BCA ASSESSMENT REPORT

Unit 12/ 14 Inman Road, CROMER NSW 2099

Client:	Strength Tribe
Reference:	20053
Revision:	01
Date:	13/08/2021

APPENDIX A – PLANS

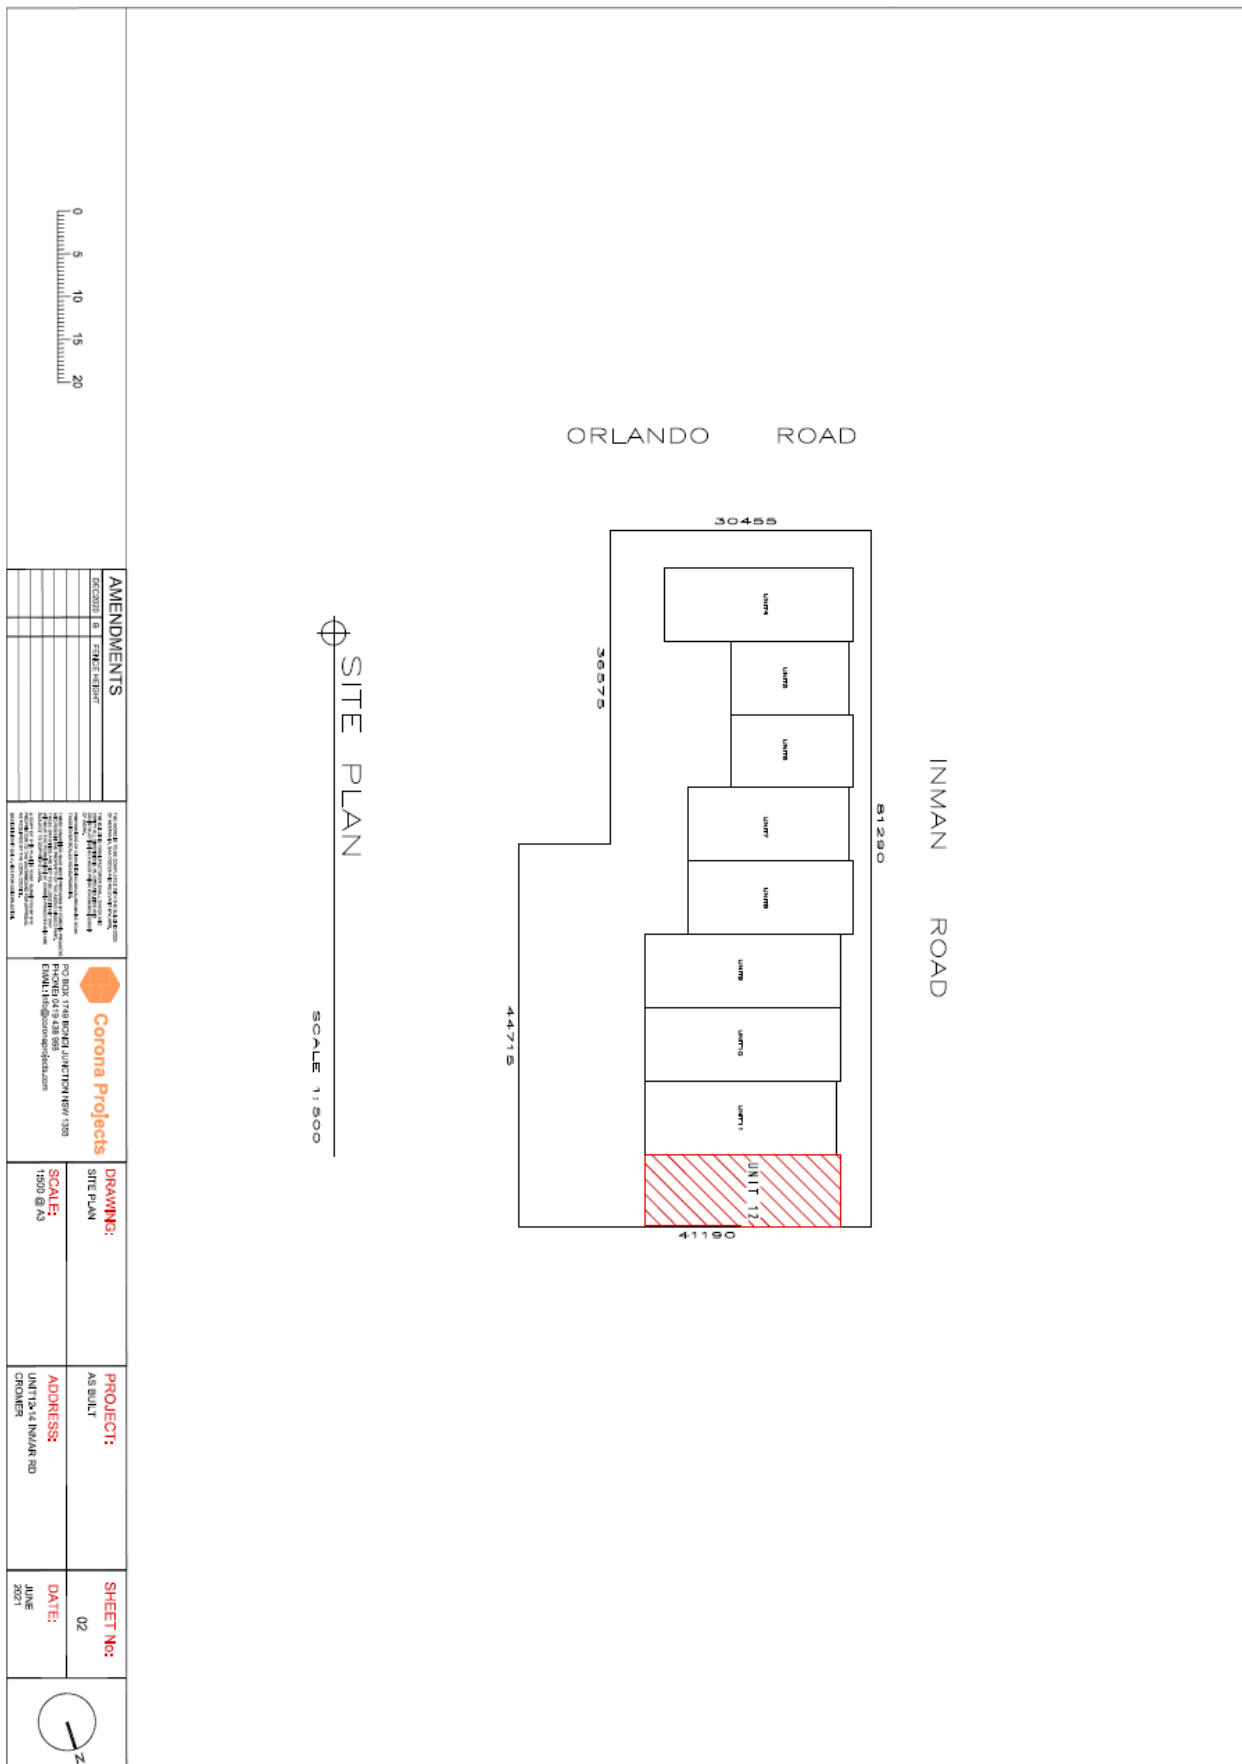
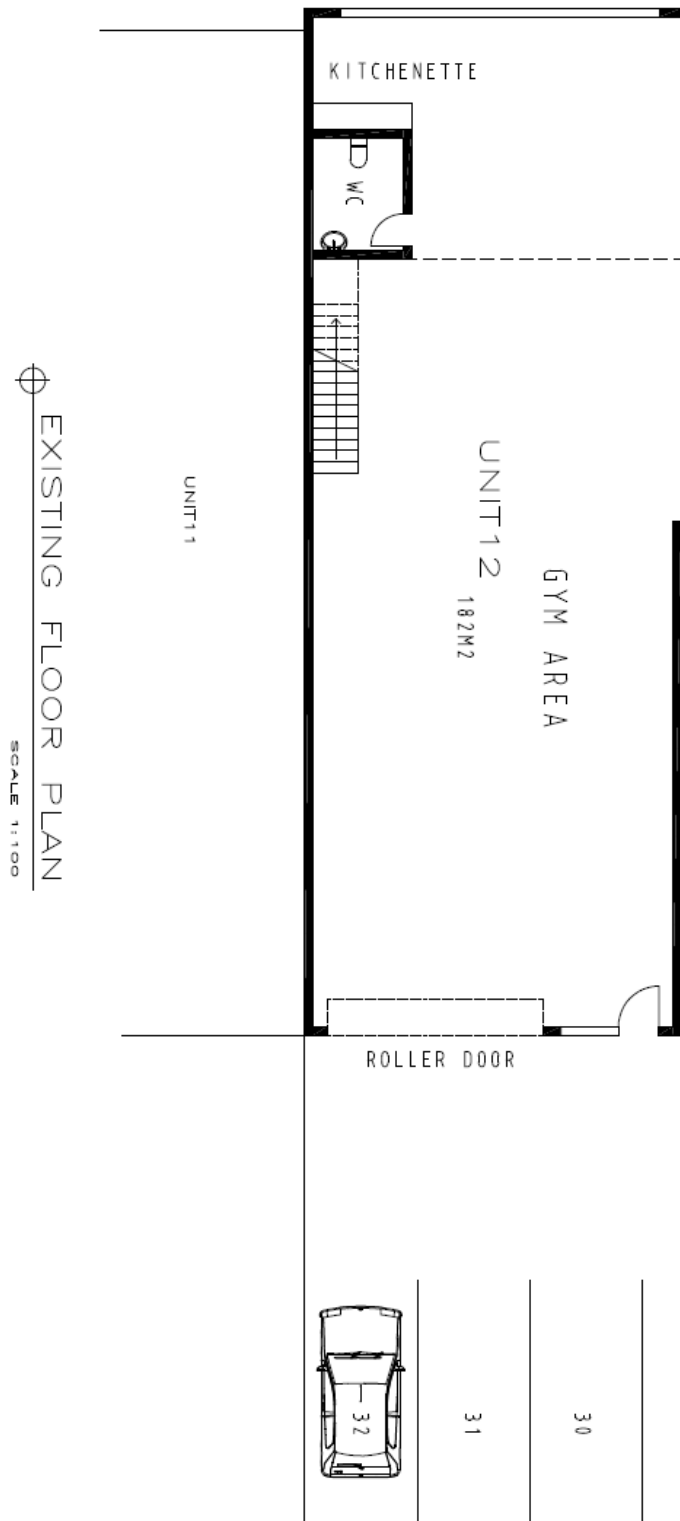
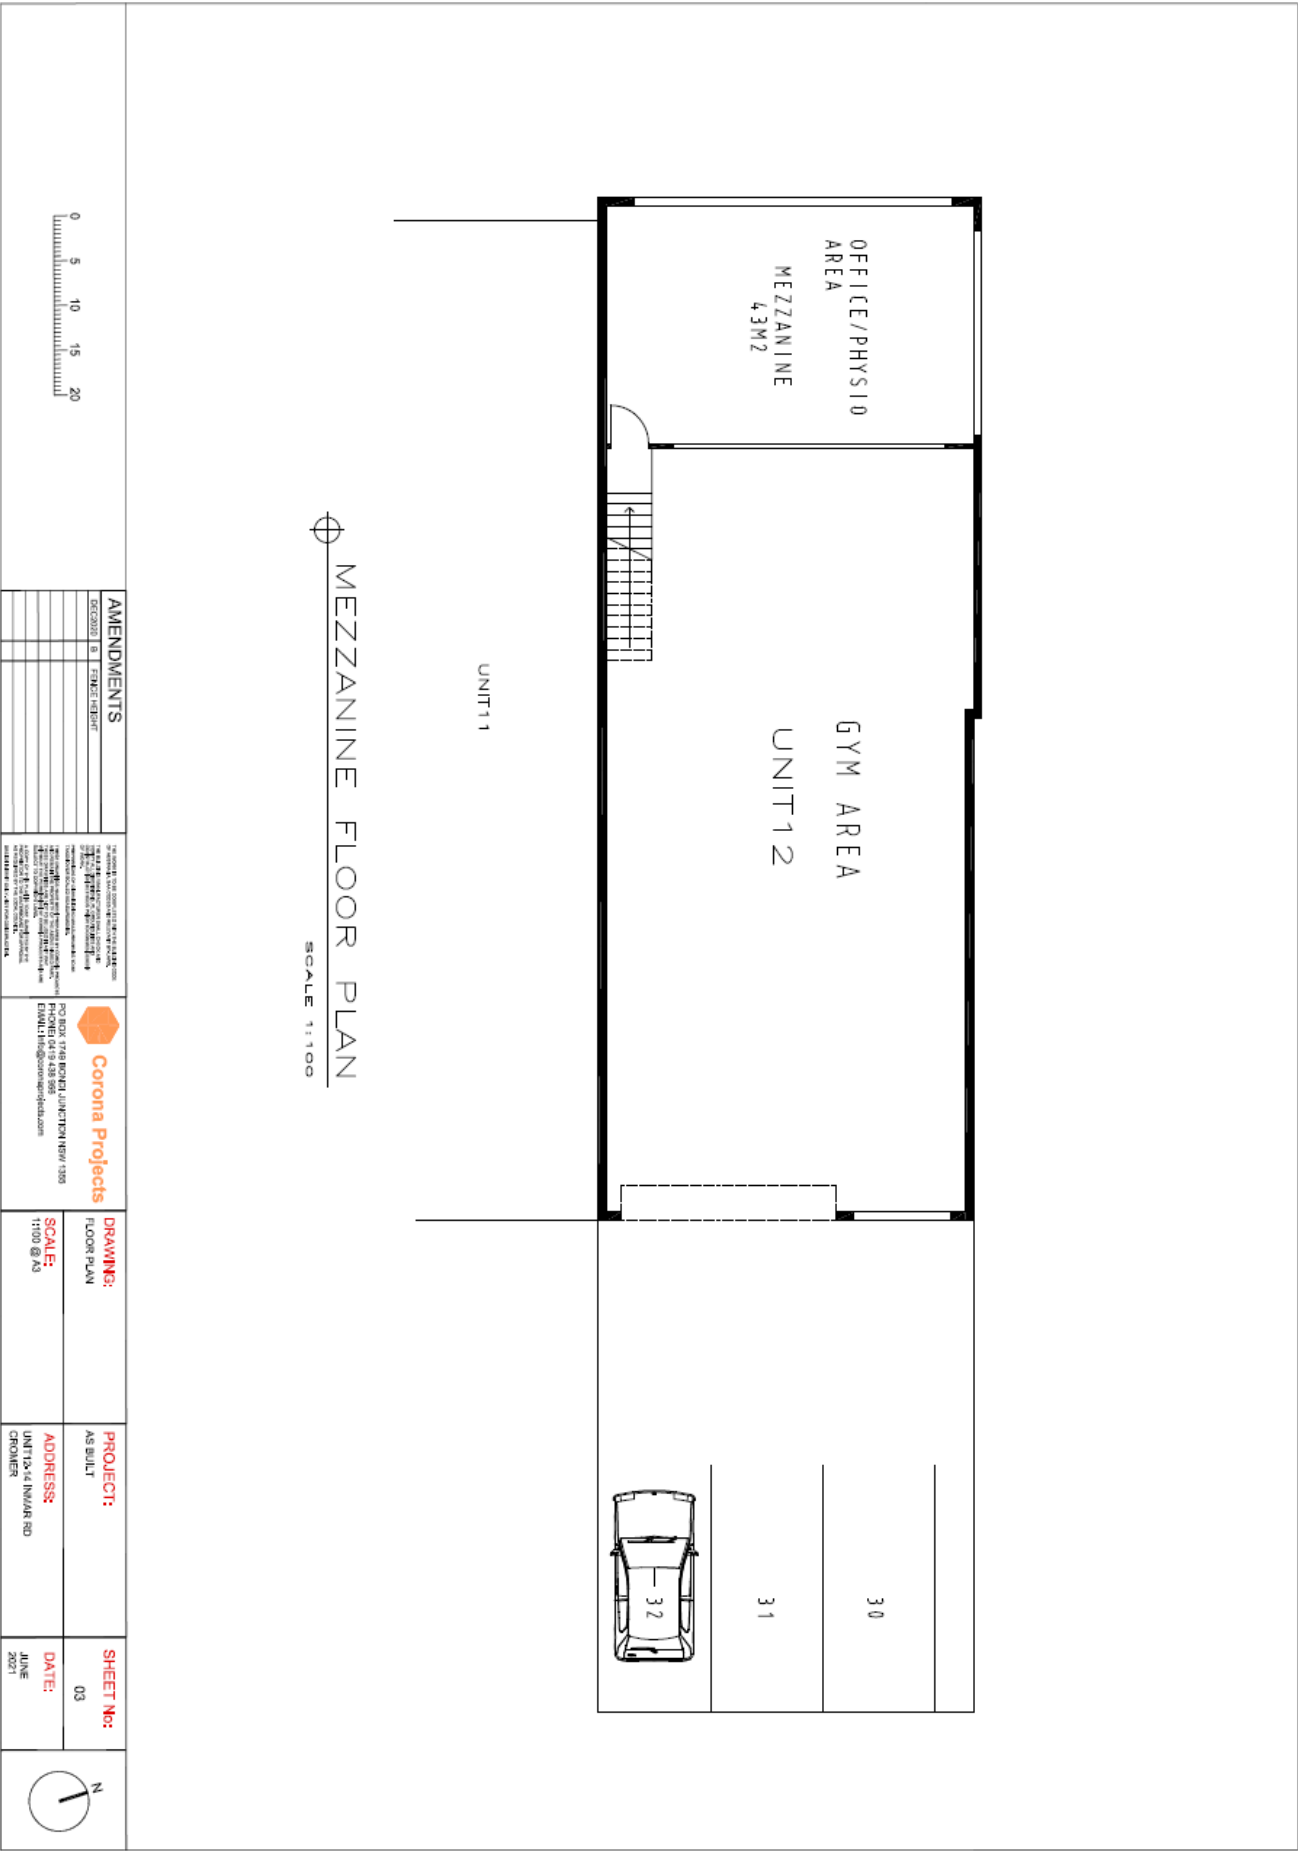
F4.9	Airlocks	The existing unisex sanitary sanitary compartment is provided with mechanical exhaust ventilation, however,	Works Required

<p>the doorway to the room is not adequately screened from view.</p> <p>It is recommended the doorway to the sanitary compartment be adequately screened from view in accordance with F4.9(b)(ii) of the BCA. This can be achieved by providing a privacy screen, partition or similar. Refer to the marked up floor plan below showing the approximate location of the privacy screen.</p>  <p>The floor plan shows a rectangular unit labeled 'UNIT 12 182M2'. On the left side, there is a 'KITCHENETTE' and a 'D WC'. A blue cloud-like shape representing a 'PRIVACY SCREEN' is positioned between the kitchenette and the main area. A 'GYM AREA' is labeled in the center. On the right side, there is a 'ROLLER DOOR'.</p>	
F4.10	*****	This clause has been deliberately left blank in the BCA.	Noted
F4.11	Carparks	The proposed development does not include any alterations to the existing carpark or the construction of a new carpark.	Not Relevant
